ADDENDUM NO. 1:

**SCHENECTADY COUNTY
BEVIS HILL COMMUNICATIONS TOWER REPLACEMENT PROJECT**

**CONTRACT DOCUMENTS FOR CONTRACT 3
RFB-2018-39**

ANTENNA PROCUREMENT AND TOWER DEMOLITION

DRAWING NUMBER	REV
C2	2

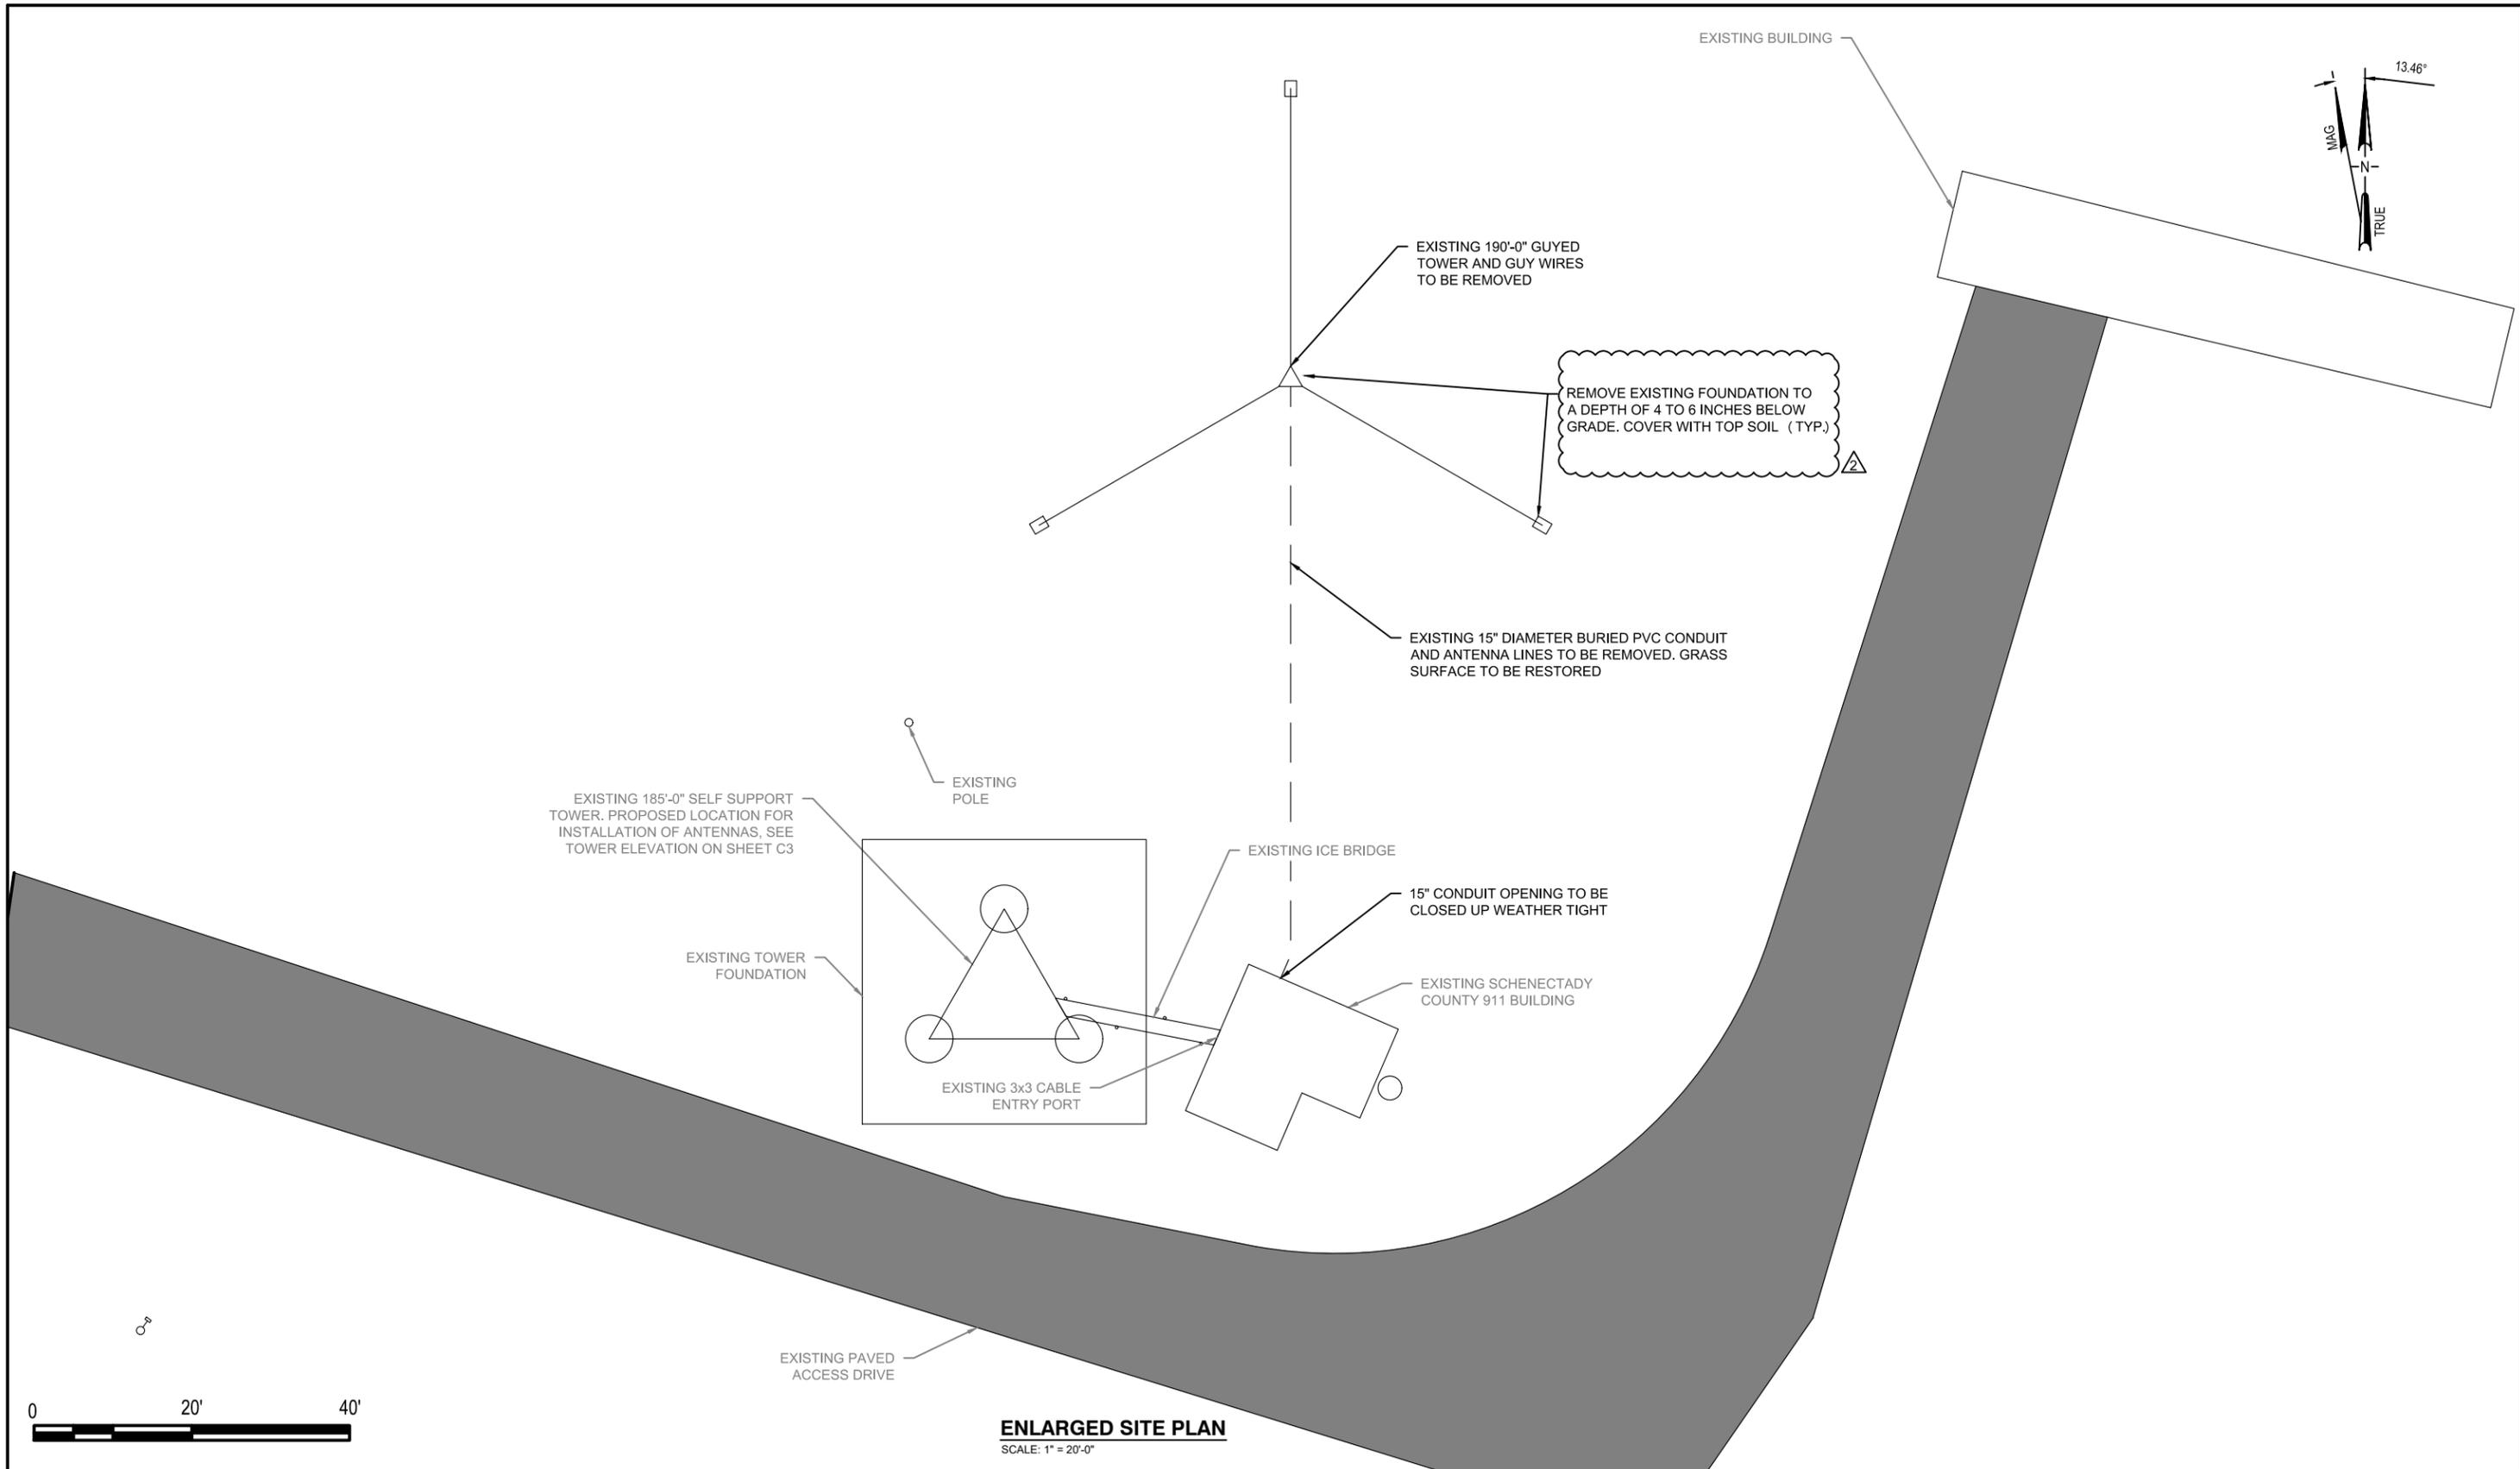
Replace Contract Drawings C2 and C4 with the revised drawings attached (C2 Rev 2 and C4 Rev 2). The notes regarding removal of existing tower anchor foundations have been revised to read: "REMOVE EXISTING FOUNDATIONS TO A DEPTH OF 4 TO 6 INCHES BELOW GRADE. COVER WITH TOP SOIL (TYP)."

SCHENECTADY COUNTY
EXISTING TOWER DEMO PLAN
 DRAWING NUMBER: **C4** REV: **2**

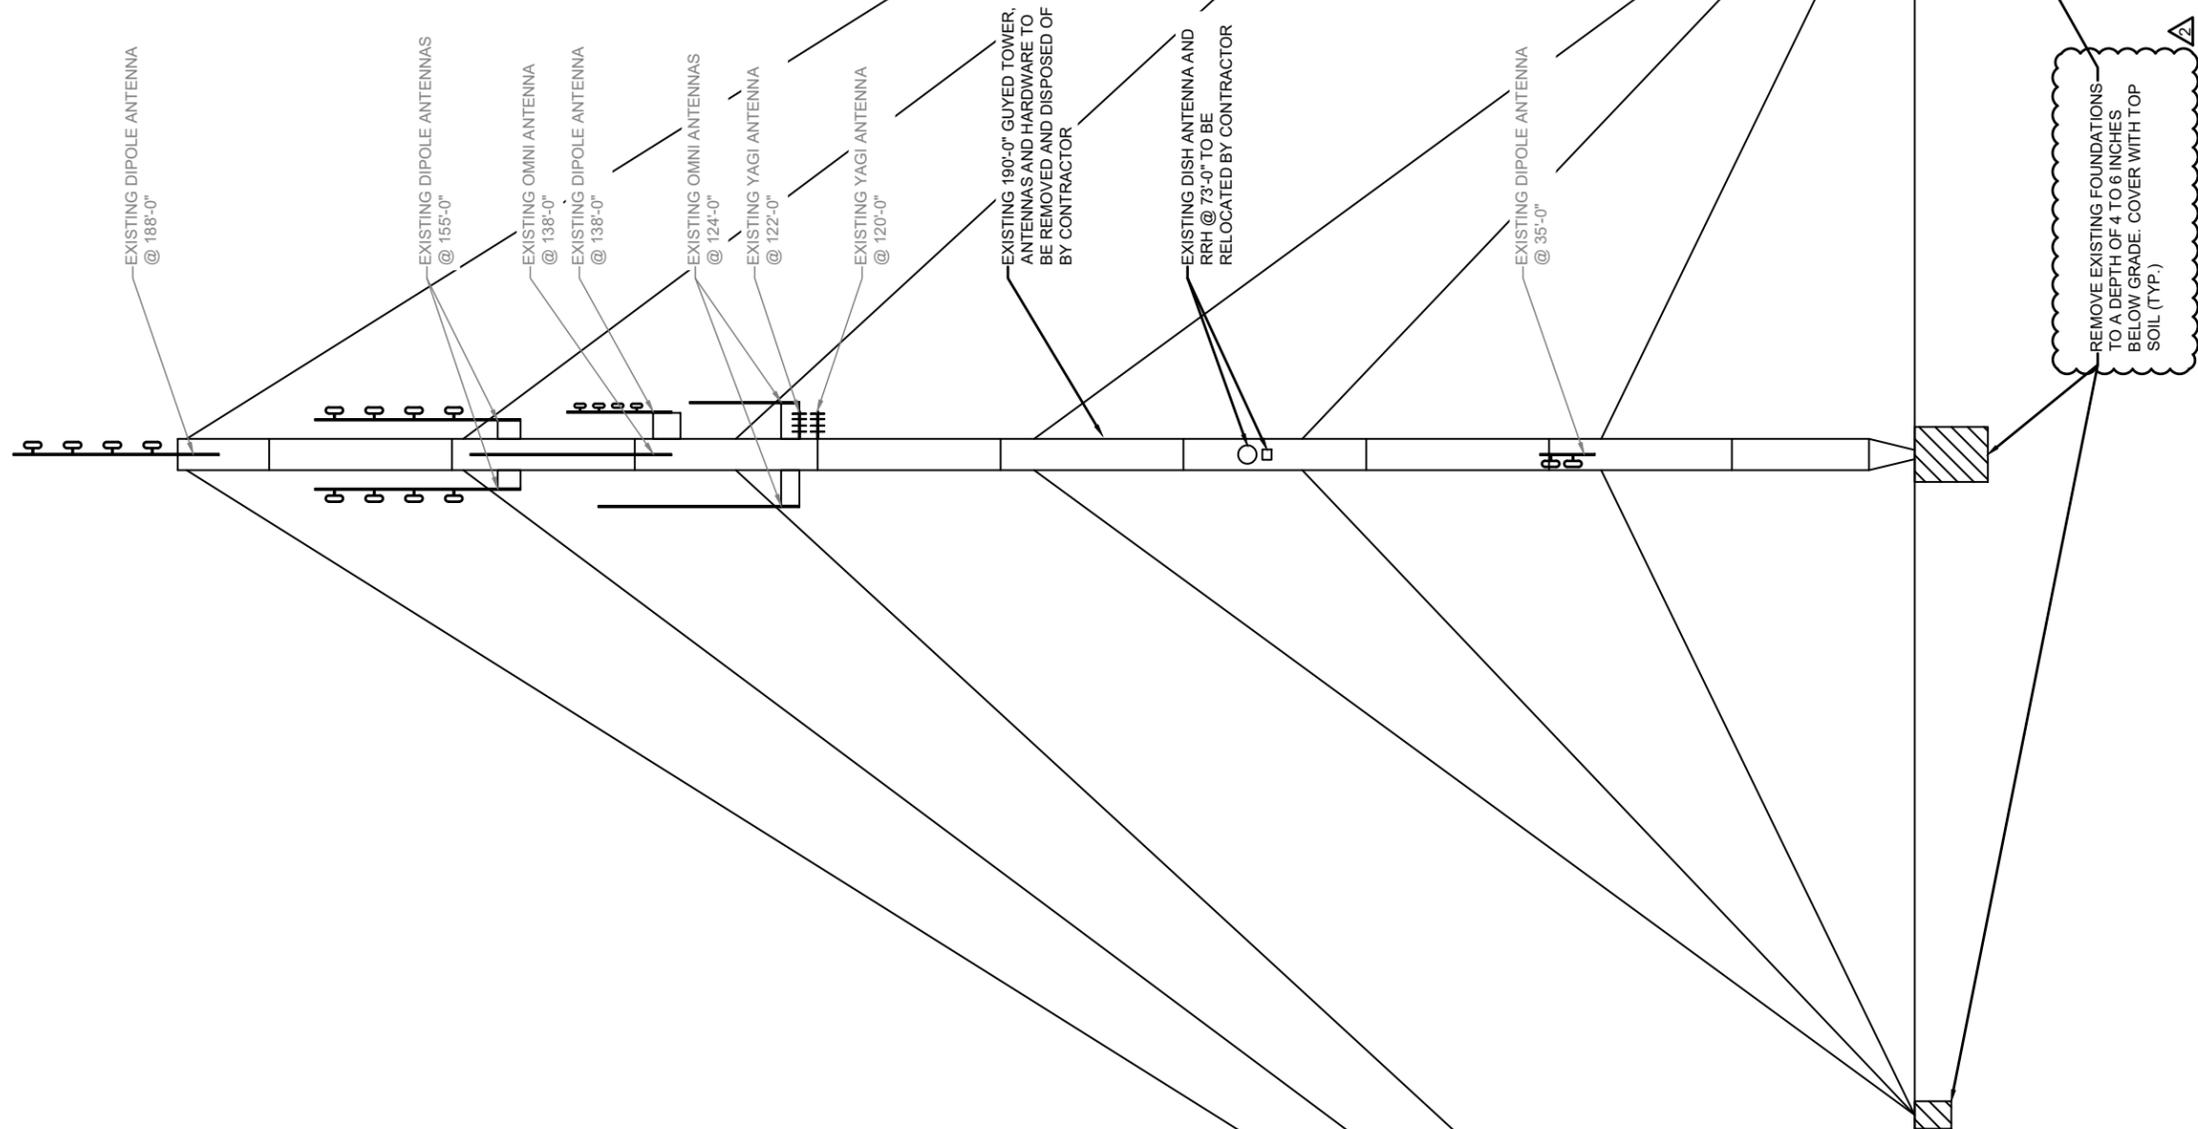
Question #1: For the decom of the existing guy tower anchors can we "shorten" the depth for the anchor near the access road?

Question #8: Is the bidder responsible for repair of the existing access driveway following anchor foundation removal, and what type of repair would be acceptable?

Answer: See Clarification #1 above.

Answer: It is not necessary to disturb the existing access driveway. See Clarification #1 above.

REMOVE EXISTING FOUNDATIONS TO A DEPTH OF 4 TO 6 INCHES BELOW GRADE. COVER WITH TOP SOIL (TYP.)
